# **Technical Letter Report on WCAP-16530-NP, *Evaluation of Post- Accident Chemical Effects in Containment Sump Fluids to Support GSI-191***

February 15, 2007

Prepared by  
W. J. Shack

Figure 2. X-ray diffraction spectra from WCAP like surrogates

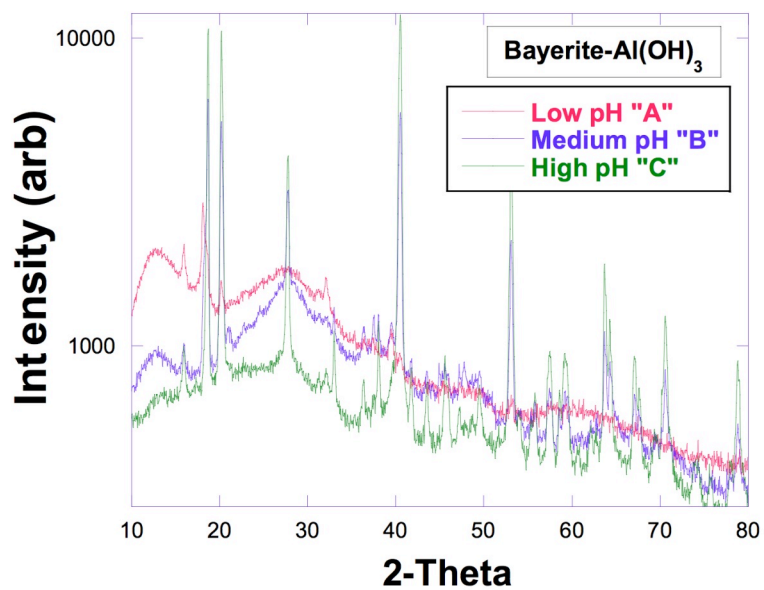
Figure 2 shows x-ray spectra from surrogates similar to those developed by the WCAP process. The pH values for the “B” and “C” surrogates are outside the specifications and these surrogates would not pass the settling test. However, it might be argued that they are chemically and physically similar. The “B” and “C” surrogates are clearly crystalline (bayerite). Because of the small size of the “A” surrogate, no clear diffraction pattern can be obtained, but it appears likely that it too is crystalline. The WCAP does not provide other information such as solubility under changing pH or temperature conditions that might provide information on whether the products are crystalline or amorphous.

However, the loop test results at Alion and ANL appear to render further discussion of the products moot. Whatever differences there are between these products and the “real” products are, the surrogate products are so effective in producing head loss, that the only important question is whether or not the products will form. If they do form, very small amounts are sufficient to produce very large increases in head loss.
